LS430

OUTLINE OF NEW FEATURES

The following changes are made for the previous LS430.

15. Combination Meter

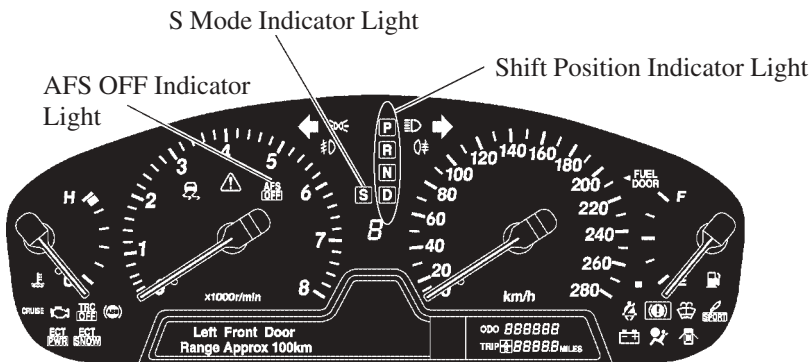
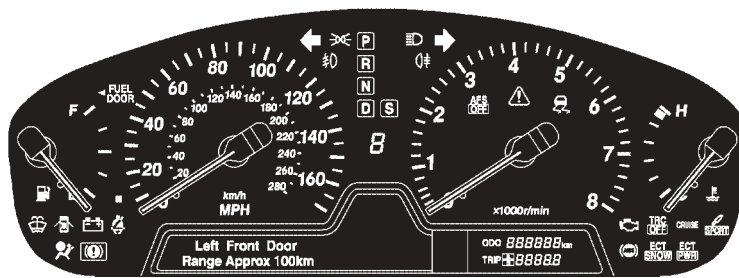
Item	Outline
Indicator Light	Along with the installation of the A761E automatic transmission, the shift position indicator light has been changed. Also, to support the multi-mode automatic transmission, shift range and S mode indicator lights have been added.
Multi-information Display	Warning messages for the dynamic laser cruise control system have been added only for Australia model.

21. Key Reminder

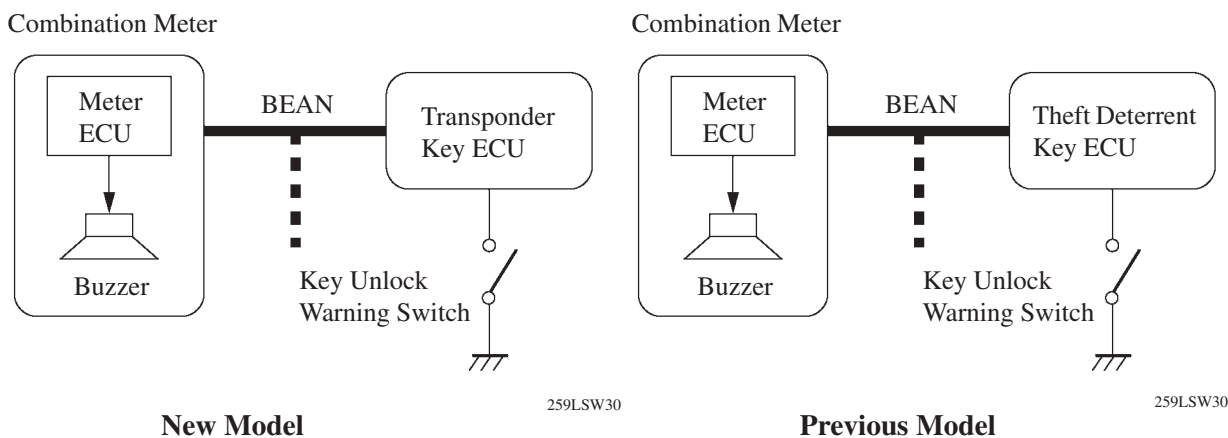
Master ECU has been changed from the theft deterrent ECU to the transponder key ECU.
